RBG-47895

SUBJECT: Supplement to the Response to License Amendment Request (LAR) for Review and Approval Of Relocation Of The Reactor Core Isolation Cooling (RCIC) Injection Point NRC Request for Additional Information (RAI)
River Bend Station, Unit 1
Docket No. 50-458
License No. NPF-47

Supplement to the Request for Additional Information (ML18172A142)

Supplement to the Request for Additional Information (ML18172A142)
RIVER BEND STATION, UNIT 1
DOCKET NO.: 50-458

Thermal Transient Loss of Feed Water Pumps Aux Power Trip without Bypass and
Reactor Core Isolation Cooling (RCIC) Injection AX-17D Rev 3K

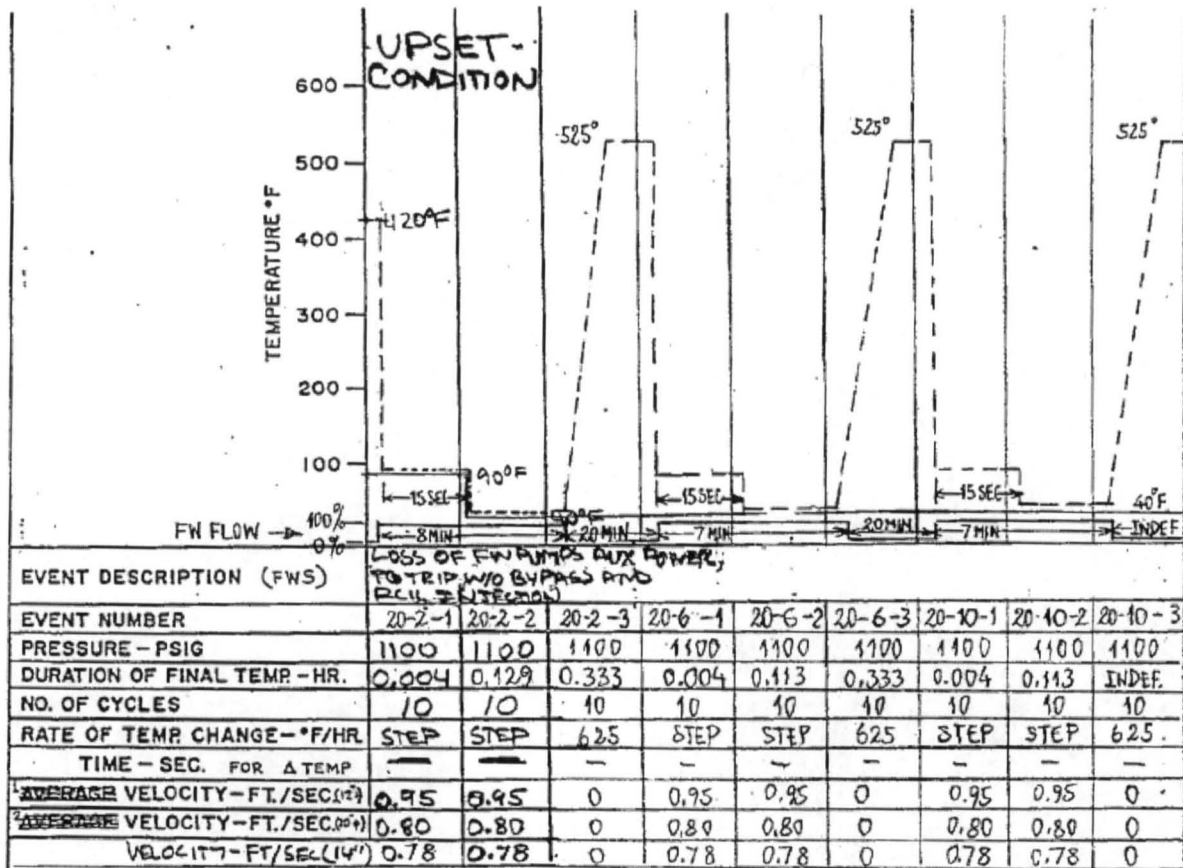
What thermal modes or transient changes and loading condition changes occurred since the cumulative usage factors and stresses decreased?

The reason for this significant CUFs reduction should be explained in detail including:

- old/new transients curves/cycles,
- fatigue stresses/cycles (S-N) combination summary, and
- the method to combine the CUFs for:
 - before the change (from 1986 beginning of the operation to the modification) and
 - after the change (after the modification to end of the operating license period).

- ***old/new transients curves/cycles,***

3K incorporated the changes made by addenda 3B, 3E, 3F, 3G, 3H, and 3J. Addendum 3K evaluated the Feedwater piping for the new function of RCIC injection in addition to the existing Feedwater functions. Attachment 4 contains the cover page to AX-017D Addendum 3K for reference. The added check valve FWS-V3052 was added to the model and new thermal mode 36 was introduced for the injection of 40 deg F RCIC into the feedwater piping. This new thermal transient includes 10 postulated events with 3 injections per event (total of 30 cycles) with no feedwater flowing. In addition to these 10 injection sequences, there are 40 postulated spurious injections with feedwater flowing. The spurious injection of RCIC with feedwater flowing events were excluded from the analysis as the contribution to stress is minimal due to the low change in feedwater temperature. The thermal transient diagram for the new thermal transient is shown in Attachment 2.

The load cases and thermal modes from Revision 3 of AX-017D are located in Attachment 1. A new thermal transient was added with addendum 3K, the transient curve can be found in Attachment 2.
